RE: City of Denton Contract Number #5753

Exhibit B
Contract Deficiencies

RE: **SITE VISIT AT DENTON ENTERPRISE AIRPORT
OCTOBER 14-15, 2015
ERECT-A-TUBE, INC. PROJECT NO. E-7754**

Project: Taxiway Queue Hangar Development, Denton Enterprise Airport
Topic: Construction Observation
Date / Time / Location: July 16, 2015 / 9:00 AM / Denton Airport Construction Site
Attendees: Quentin Hix, David Schaumberg, Zac Loiselle, Scott Aukerman, Dave Powyszynski, Richie Dailey and Hasim Isufaj
Distribution: Attendees; File

Picture 4

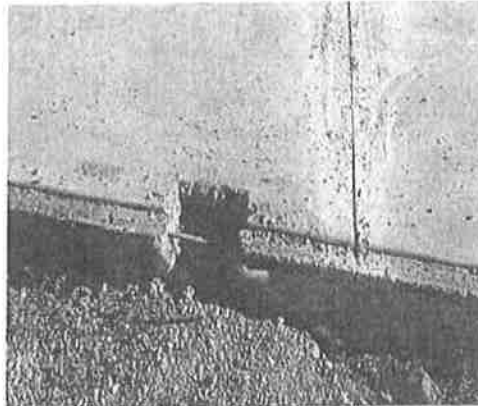
aligns with grade beam centerline. Refer to SK-4 for proposed solution.			ARI
	2. Floor socket embed plates per Erect-A-Tube submittal were not installed, refer to Picture 4.			MAG

Picture 5

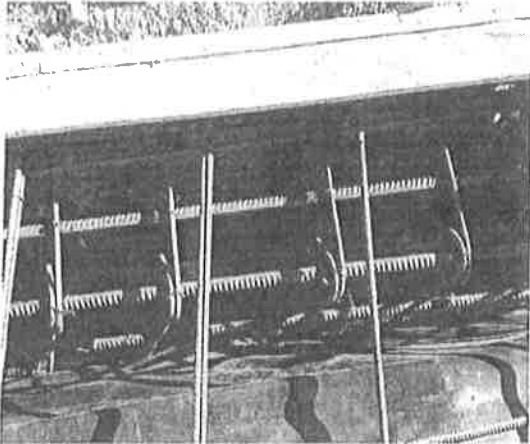
3. Pier rebar exposed, refer to picture 5.			MAG
	Proposed solutions: 1) Refer to SK-4.			ARI
	<u>Building 2051 Skylane and 2061 Skylane</u> On-going construction activity:			
	Work was in progress, and it was 85% (approximately) complete.			
	<ul style="list-style-type: none"> Scheduled grade beam and slab on grade reinforcing was provided per documents. Grade beam corner bar reinforcing installation was in progress. Most of anchor rods were installed. Anchor rods at interior columns were not installed at time of visit. Socket embed plate per Erect-A-Tube were not installed at time of visit. 			MAG
				MAG
				MAG
				MAG
	Discrepancies:			MAG

Picture 6

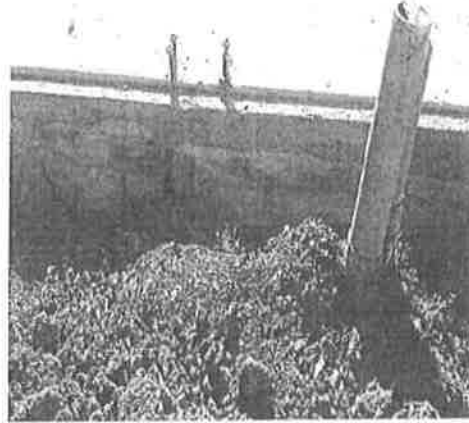
3. Bottom bar splicing was not conforming per construction documents (detail 2/S301). Add additional 3-#7 bars between piers per SK-5.			MAG
	4. Scheduled stirrups were provided per documents, however it was difficult to verify spacing, due to stirrups being inclined, refer to picture 6.			MAG

Picture 7

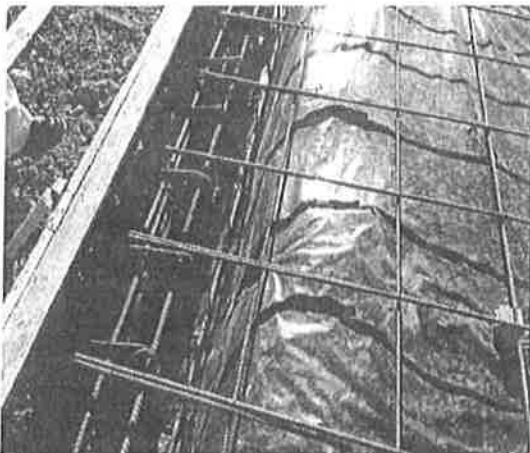
1. All piers and most of grade beams have not been cleaned of dirt and debris. Refer to picture 7 & 8.			MAG
	2. Wooden and concrete blocks were for grade beam and slab reinforcing, refer to picture 9.			MAG

Picture 15

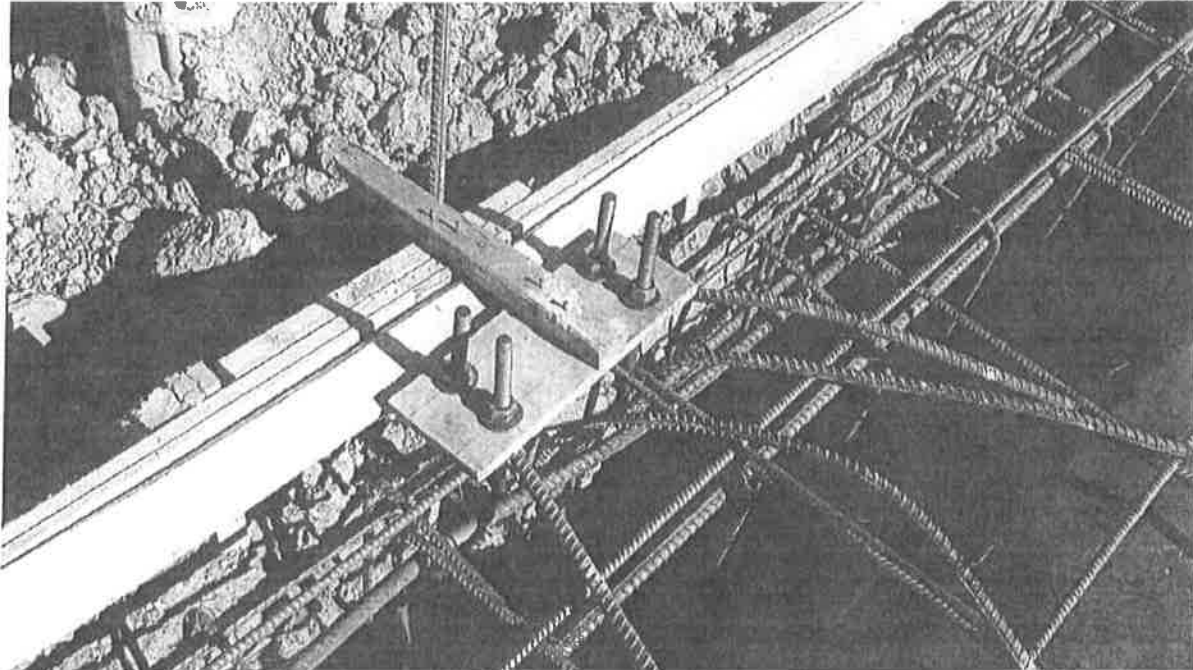
10. Pier dowel outside building perimeter, refer to picture 15.			MAG
